PHASE ONE - TUMBLEWEED

RE: REVISED DRAINAGE PLAN FOR PHASE ONE, TUMBLEWEED INDUSTRIAL PARK
(L-20/D13D) REVISION DATED SEPTEMBER 3, 1991

**GRADING & DRAINAGE PLAN
PHASE ONE
TUMBLEWEED INDUSTRIAL PARK**

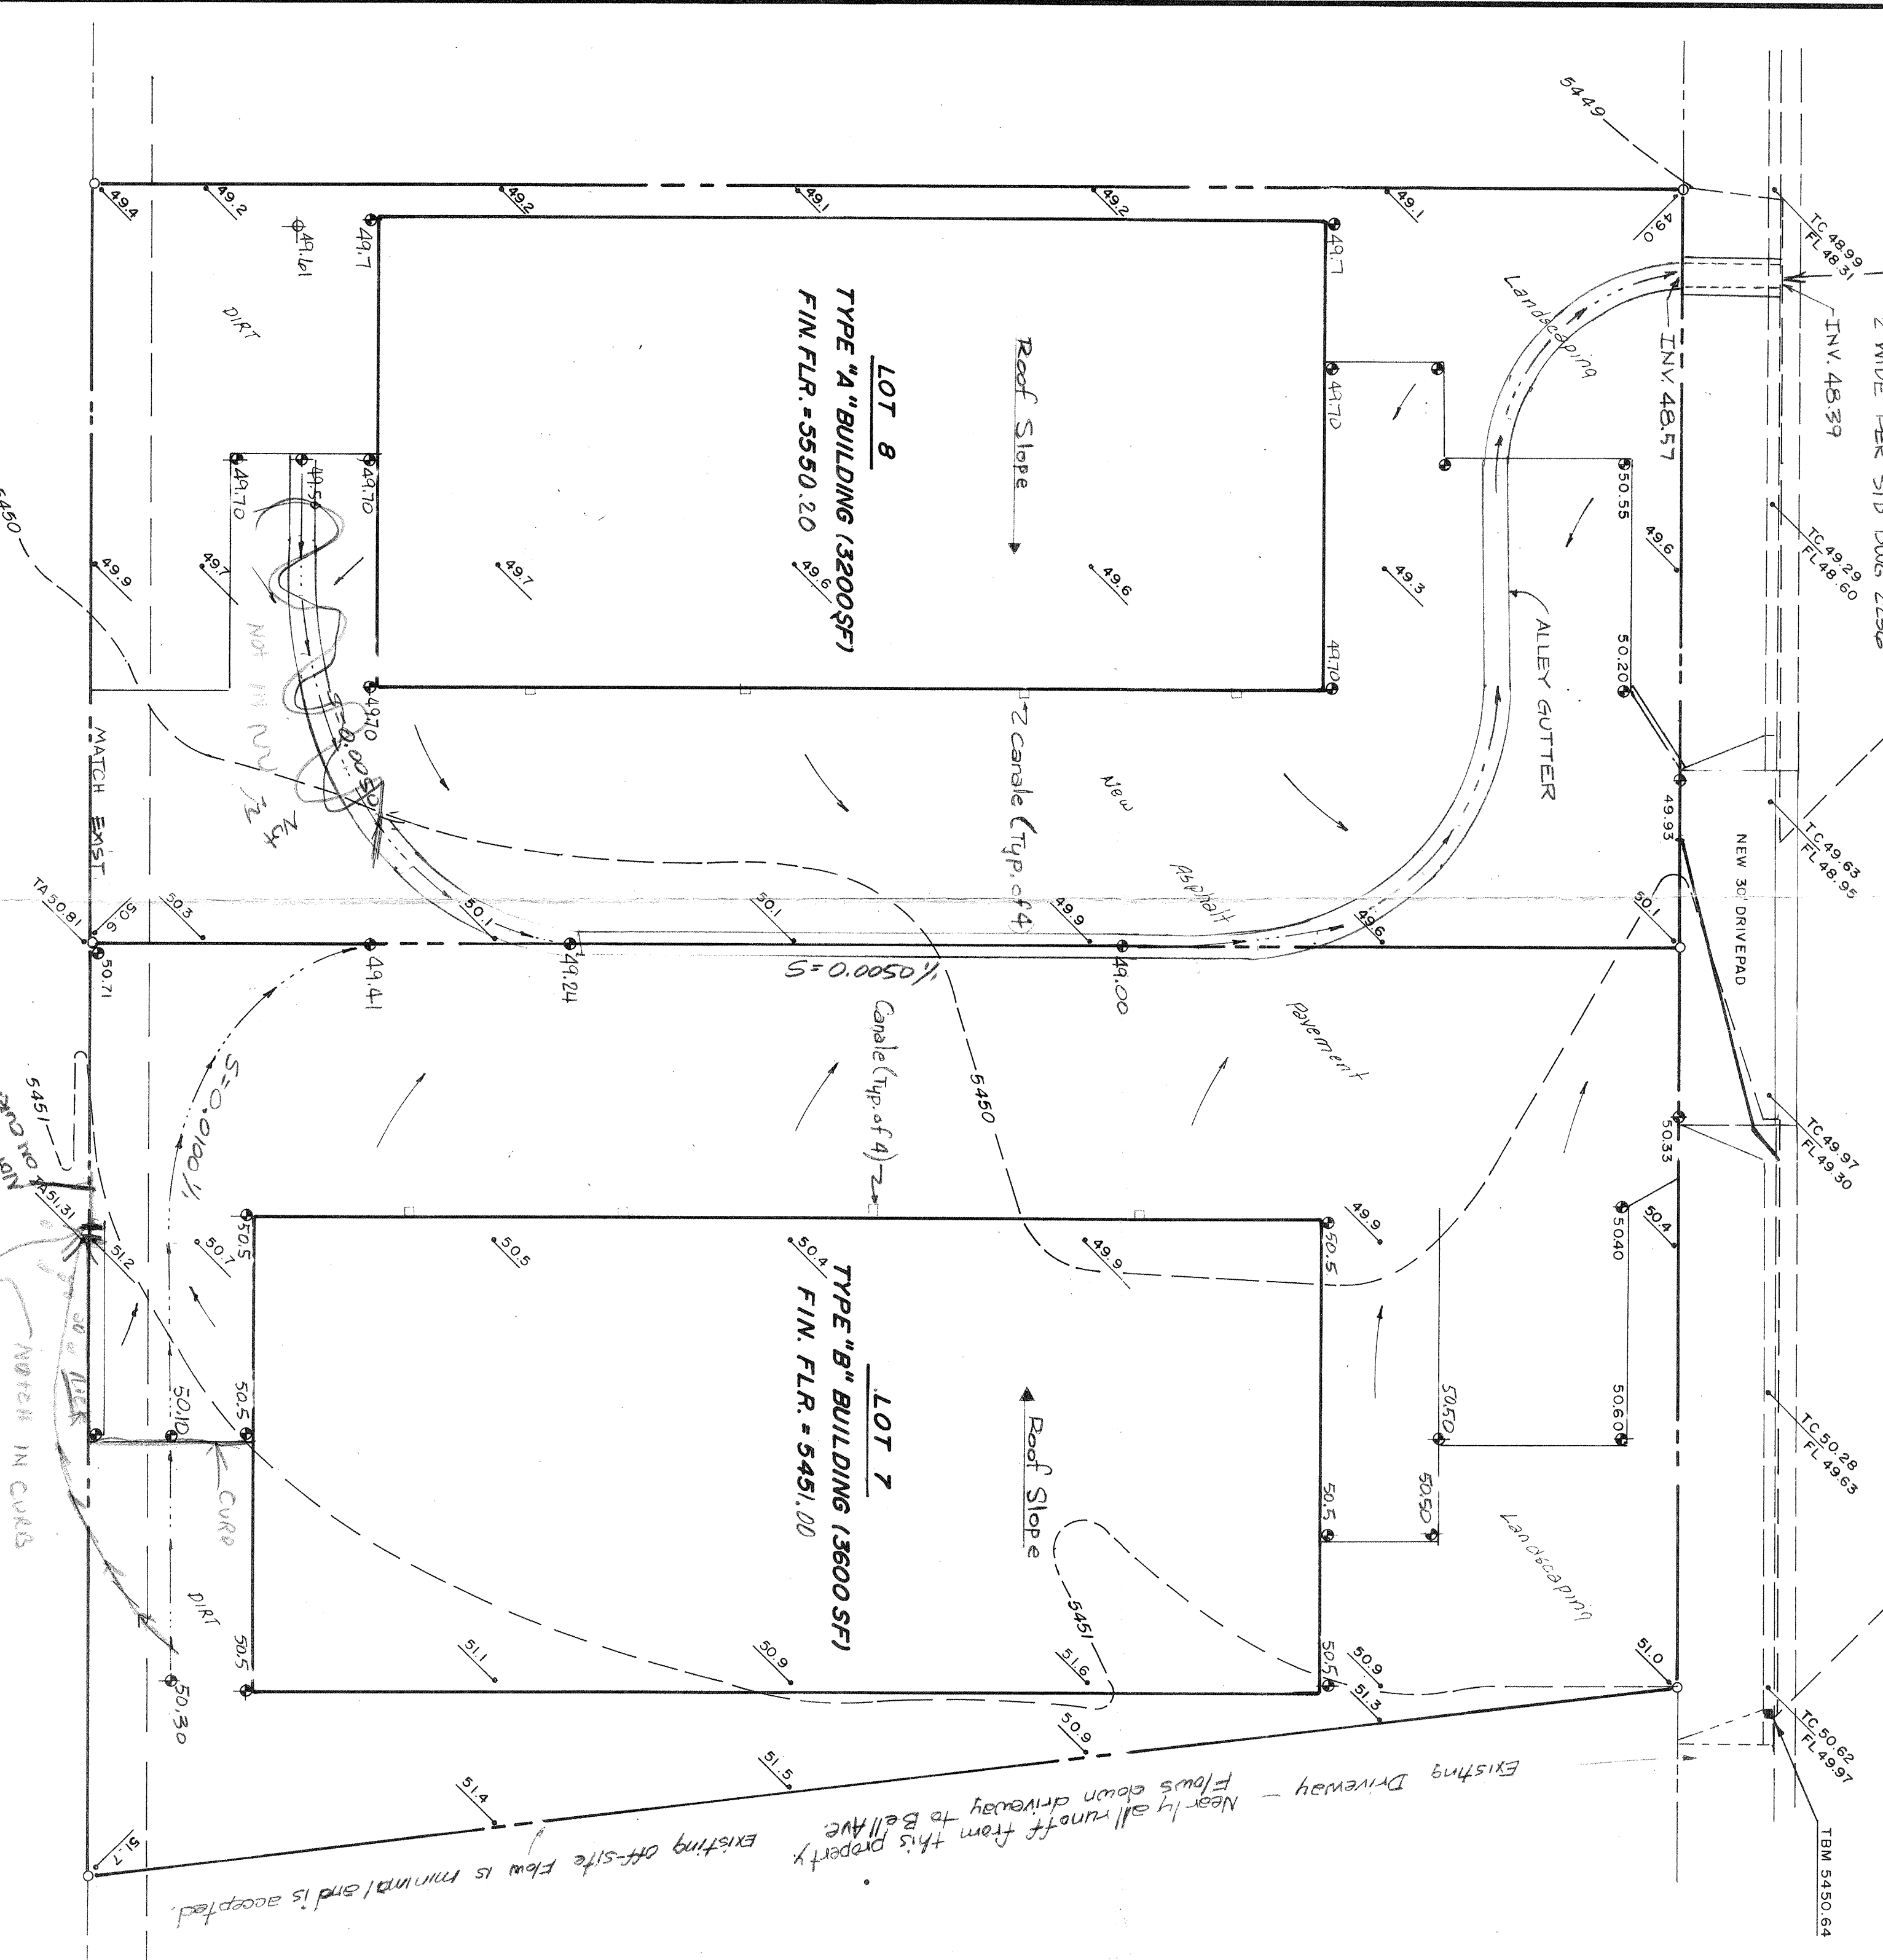
DATE SUBMITTED: SEPT 3 July 22, 1991BY: Frank D. Lovelady
Frank D. Lovelady, P.E.OTHER LOWERED GRADES (SPECIFY)& ADDED SW CULVERTTO REDUCE AMOUNT OF FILL

Based on the information provided on your submittal of September 3, 1991, the above referenced plan is approved for Building Permit.
